Our Ref: N0241372-CLTR-01A

Project: Class 2 Mixed-use Project

Address: 37 Archer Street
Chatswood NSW 2067

Appendix A – 37 Archer Street Comments Register

Appendix B – Longitudinal Section

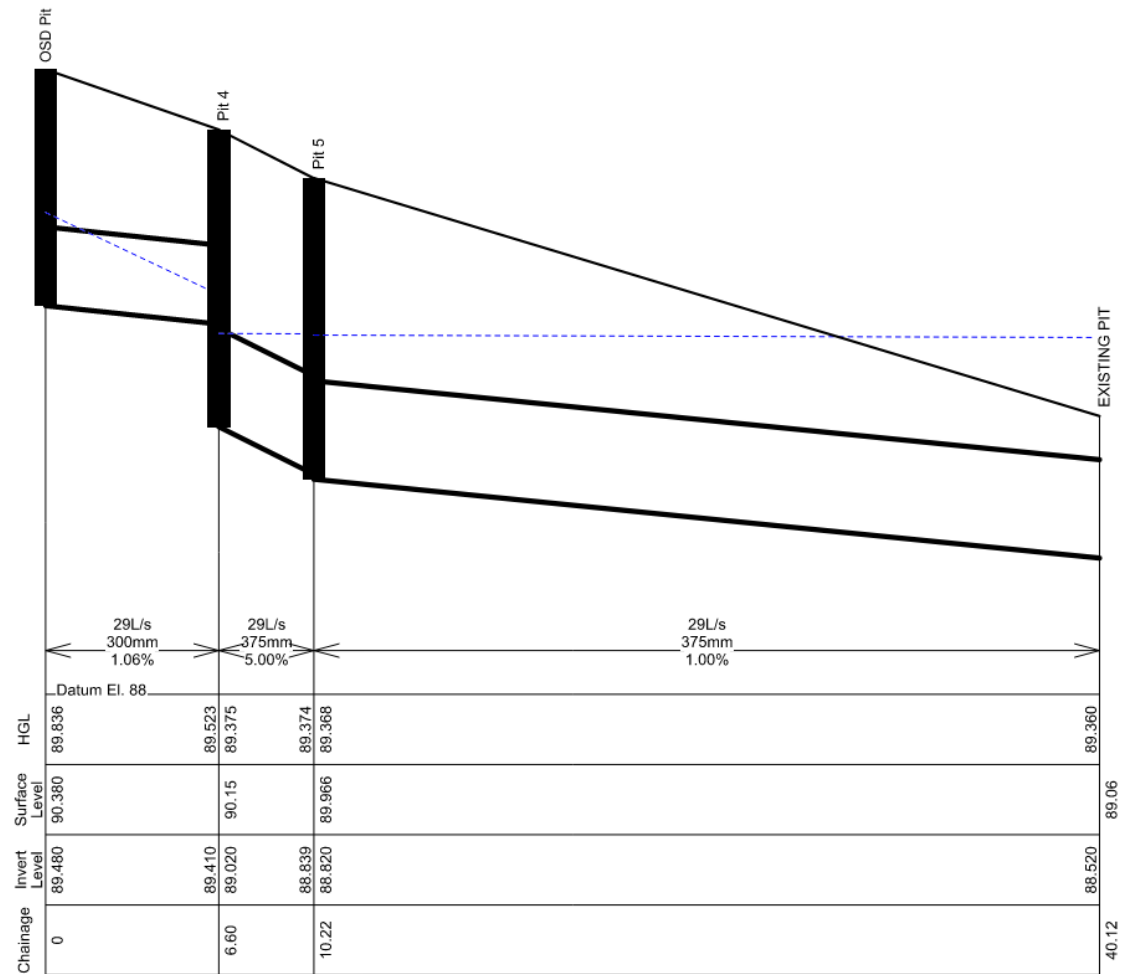
REVIEWER				JN	
Item No.	Source	Organisation	Comments	JN Response	Design Document Reference
1	Item 8 of DPHI RFI Matrix	Department of Planning, Housing and Infrastructure	Ensure consistency between basement levels in the architectural plans and the integrated water management plan.	Civil plans (including integrated water management plan), have been updated to be consistent with basement levels shown in architectural plans.	Civil Drawing Set Sheets N0241372 C001 to C200.
2	Item 8 of DPHI RFI Matrix	Department of Planning, Housing and Infrastructure	Clarify the need for hydrocarbon treatment during construction dewatering, as noted in the hydrogeological report.	This is not part of the civil design scope of works.	N/A
3	Item 8 of DPHI RFI Matrix	Department of Planning, Housing and Infrastructure	Confirm that the on-site detention (OSD) outflow is above the 1% AEP flood level.	OSD outflow is above the 1% AEP flood level at the point where the OSD tank is connecting to Council's existing drainage system. Refer JN's response to Item 4.	Drawing N0241372 C205.

4	Section d) Stormwater Management of Attachment 1 – Council Submission	Willoughby City Council	The stormwater management plans include an on-site stormwater detention system and water quality improvement system as required by Council's Technical Standard 1. However, there are	Outlet of the OSD tank is above the downstream 1% AEP water level. Refer to Appendix B of this report, for longitudinal section of the proposed drainage line	Drawing N0241372 C205.

<p>elements of the system that do not comply with Council's requirements and will impact the operation of the system.</p> <p>As the system is required to be designed to cater for storms up to the 1%AEP event, the tank needs to be located at a level where the outlet of the tank is above the downstream 1%AEP water level. This is required to ensure that the tank outlet is not impacted by the downstream water level, which will impact the operation of the orifice / outlet. In order to demonstrate that the tank is not impacted by the downstream water level, a longitudinal section needs to be provided from the connection point to the Council system to the outlet of the OSD tank. The section needs to include a hydraulic grade line analysis, with the adopted downstream water level the 1%AEP water level as per the Flood Impact Report prepared for the development.</p>	<p>(including hydraulic grade line analysis), from the OSD tank outlet to Council's existing drainage system on Bertram Street.</p> <p>1% AEP water level at the point of OSD connection to Council's existing drainage infrastructure, has been adopted as per the Flood Impact Report.</p>
